**Staff Analysis of Proposed Amendment to the
Dane County Water Quality Plan,
Revising the Cottage Grove Urban Service Area Boundary and
Environmental Corridors in the Town of Cottage Grove**

Prepared by staff
of the CARPC.

Map 6C – Elevations – Drumlin Grove

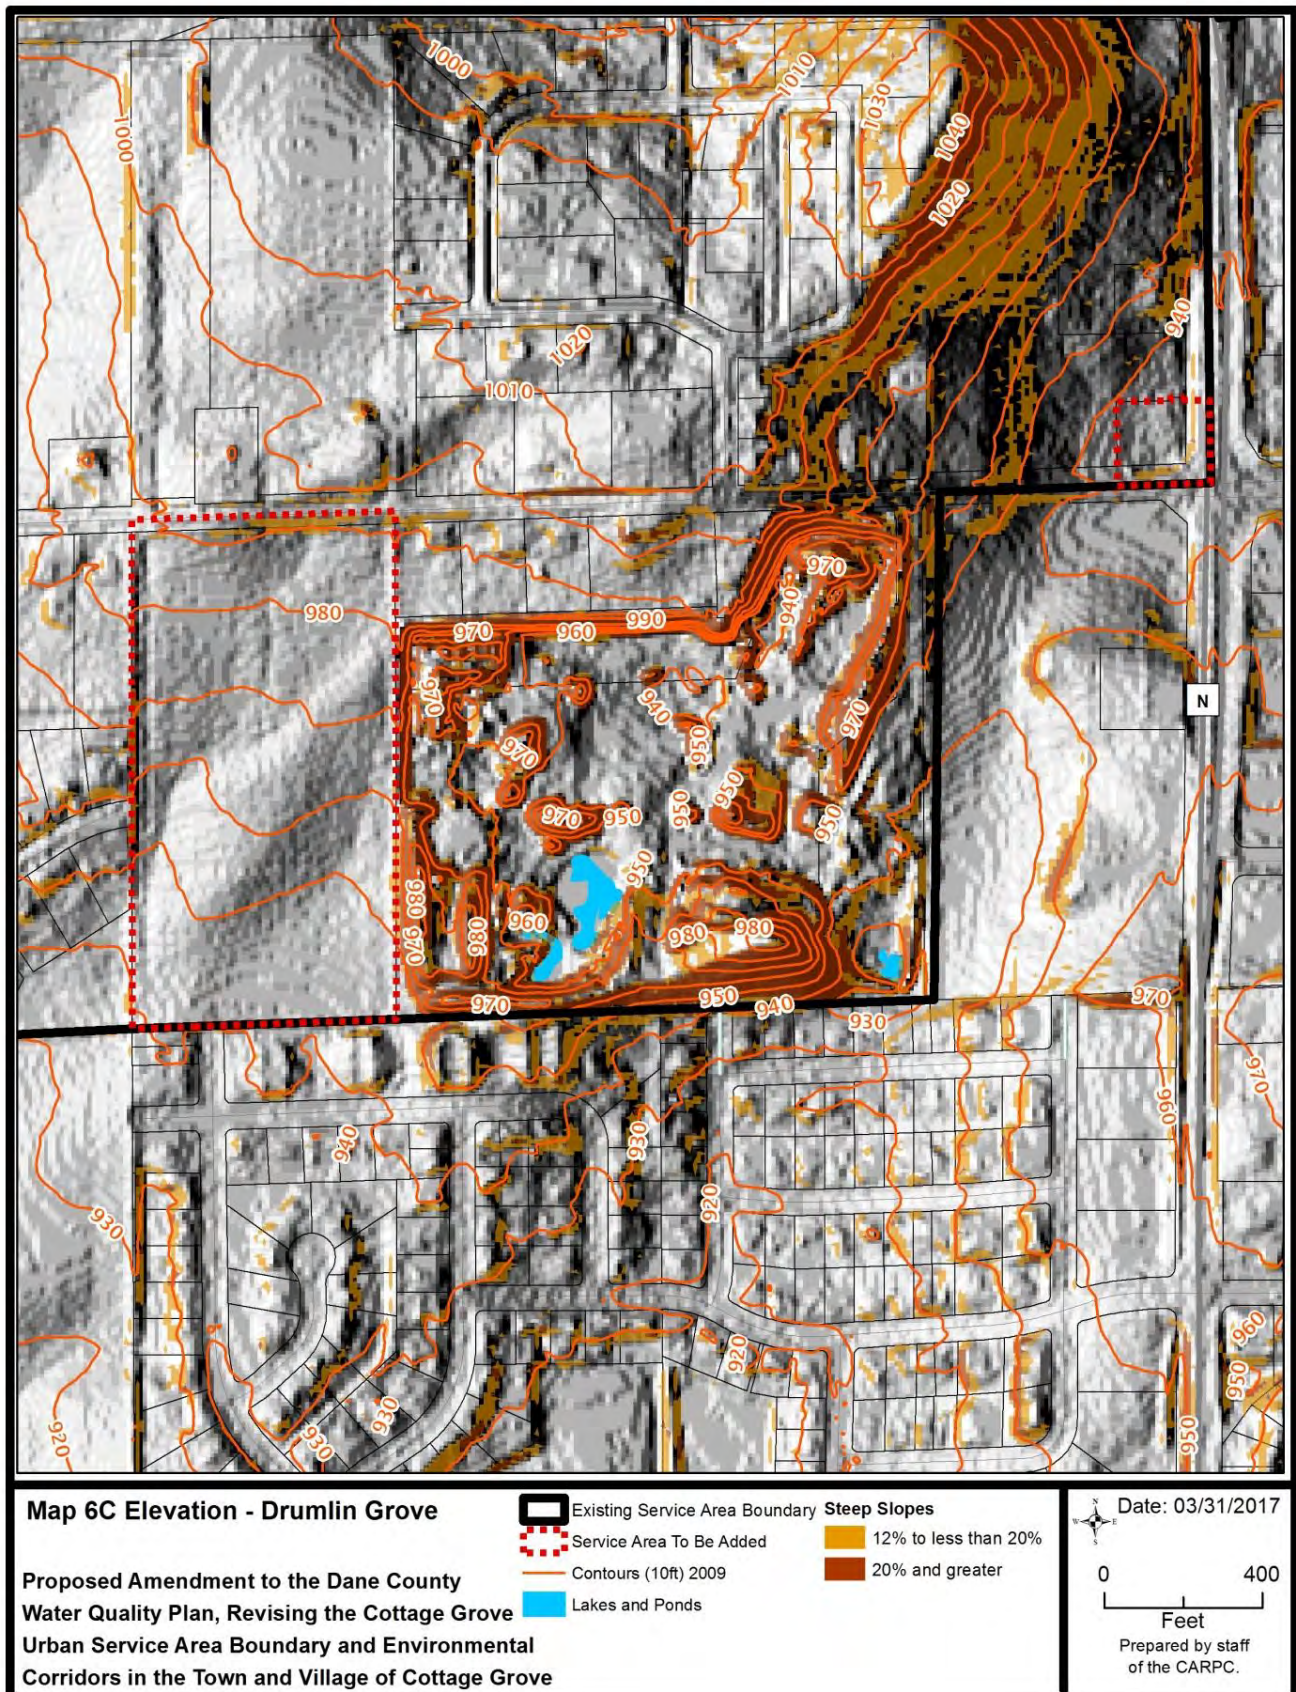
Based on the WGNHS Karst Potential map the northern two-thirds of the main Drumlin Grove amendment area is within an area where the depth to bedrock over potential karst units is 8 to 33 feet. Regional Planning Commission staff recommends the collection of site-specific data for an accurate assessment of karst potential in this area. If karst features are found, adequate protection measures must be taken to address the potential for groundwater contamination.

2. Based on the WGNHS Karst Potential map the northern two-thirds of the main Drumlin Grove amendment area is within an area where the depth to bedrock over potential karst units is 8 to 33 feet. Regional Planning Commission staff recommends the collection of site-specific data for an accurate assessment karst potential in this area. If karst features are found, adequate protection measures must be taken to address the potential for groundwater contamination.

Map 8 Potential Seasonal High Groundwater - Widen Olson

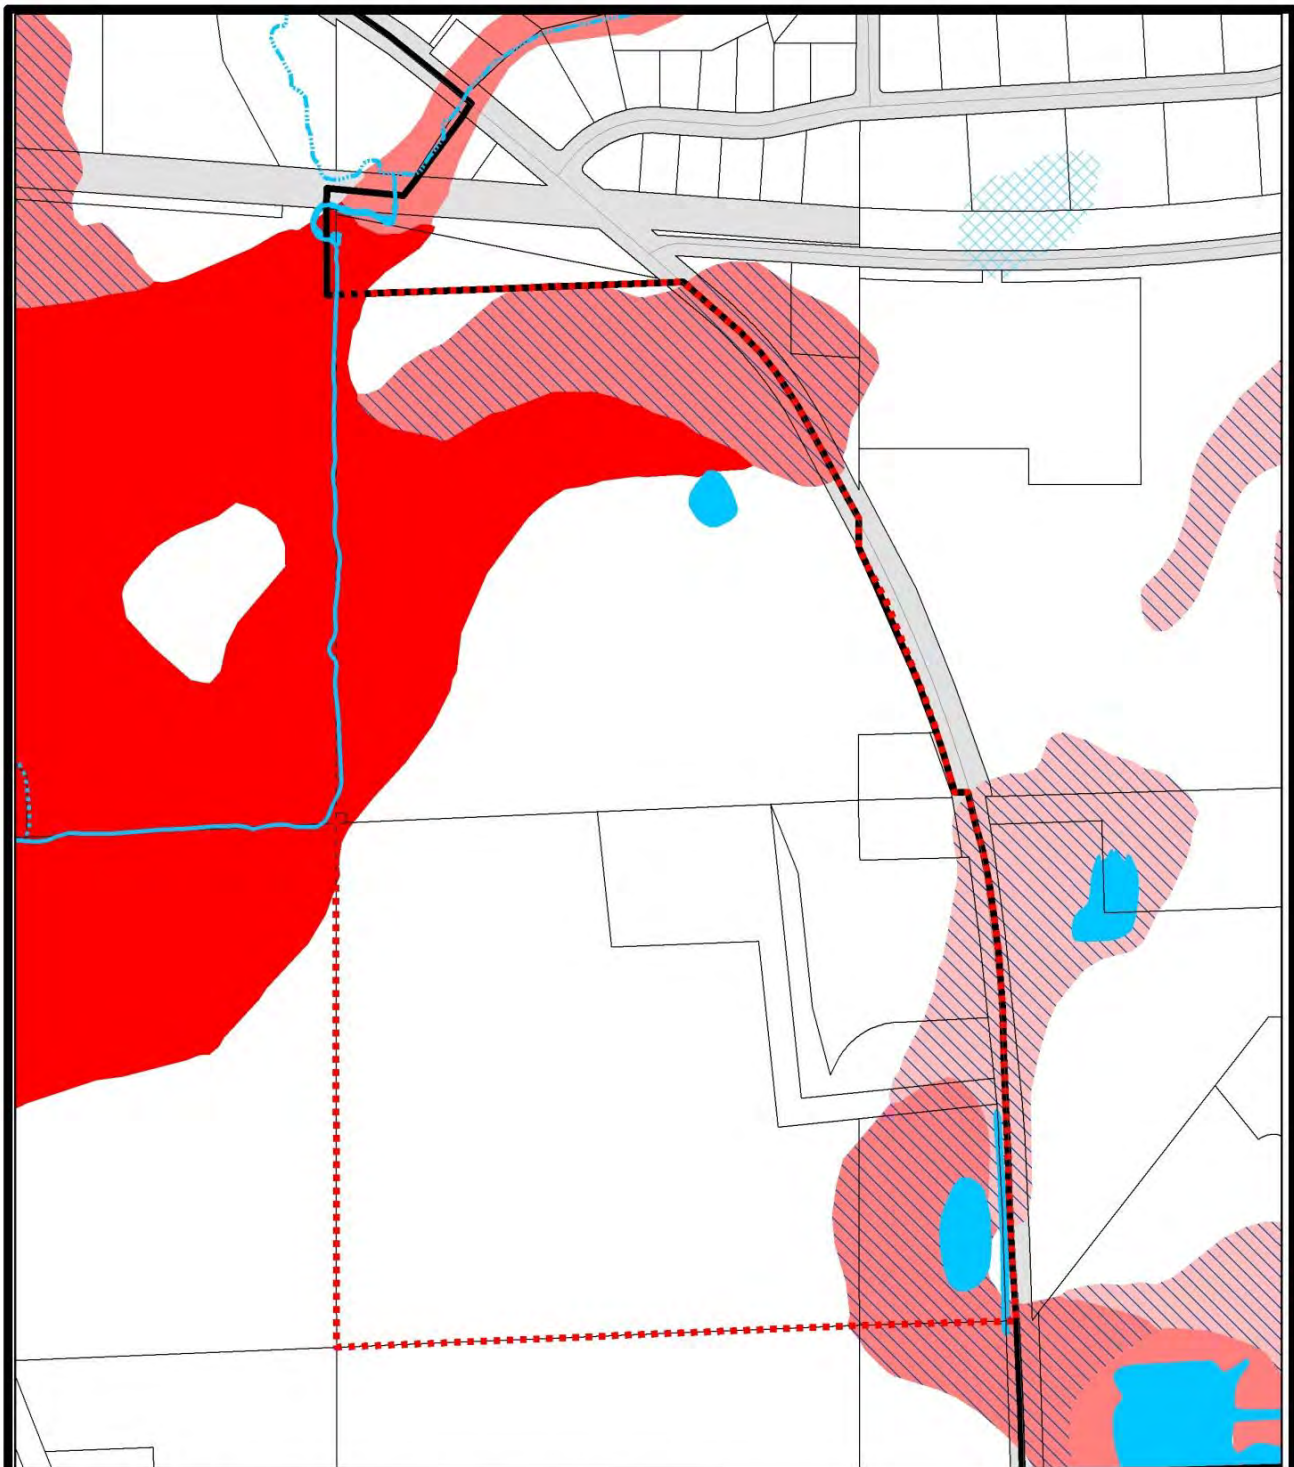
The Widen Olson amendment area includes some mapped hydric soils and poorly drained soils in areas with seasonal high groundwater tables. These soils can have limited suitability for buildings with basements due to their seasonal high water table (zone of soil saturation), which can cause problems with groundwater induced flooding. Regional Planning Commission staff recommends that on-site soils investigations in accordance with SPS 385.60 be conducted in areas with these soil classifications to determine the actual extent of seasonal high groundwater in the amendment areas and identify potential problem areas. It is further recommended that the Village consider requiring that the lowest level of any structure be built at a minimum of one foot above the seasonal high groundwater table and have this restriction recorded on the plat. This type of restriction is being used in several counties in Wisconsin and will reduce the potential for basement flooding.

1. Conduct on-site soils investigations in areas with mapped hydric soils and with poorly drained soils and seasonal high groundwater tables in the Widen Olson amendment area to determine the actual extent of seasonal high groundwater and identify potential problem areas. The Village should consider requiring that the lowest level of any structure be built at a minimum of one foot above the seasonal high groundwater table and have this restriction recorded on the plat to reduce the potential for basement flooding.
